To: Joe Dichoso
Joe.Dichoso@fcc.gov
FCC Application Processing Branch

Re: FCC ID QJQ-PE-PRO-TLF

Applicant: Sensors & Software Inc.
Correspondence Reference Number: 26929
731 Confirmation Number: EA478068

Figure 1: View of connector on bottom of transmitter.

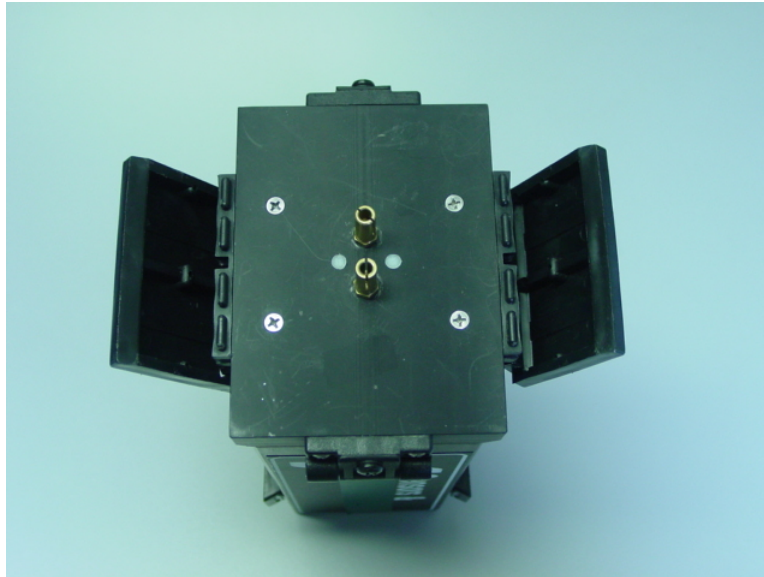
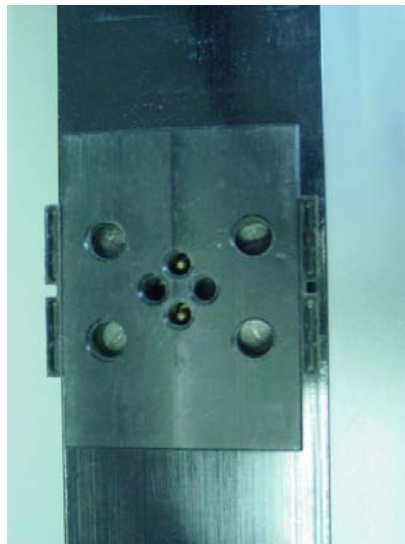
- 5) **It appears that the 50, 100 and 200 MHz antennas are interchangeable and the antenna is not permanent as stated. How does the device comply with 15.203.**

The antenna connection consists of 2 pins and a unique mechanical structure that allows the attachment of the transmitter electronics to the antenna. Like any connector, there is an electrical component (the 2 pins) and a mechanical component (the shell and support structure). The uniqueness of the support structure ensures incompatibility with antennas other than those designed for this system. By its nature the system is required to be moved over the ground with all the attendant stresses on the antenna and attached electronics. Operation of the system without this coupling mechanism is impractical. See Figures 1 and 2 that show the connector on the bottom of the transmitter and on the antenna respectively.
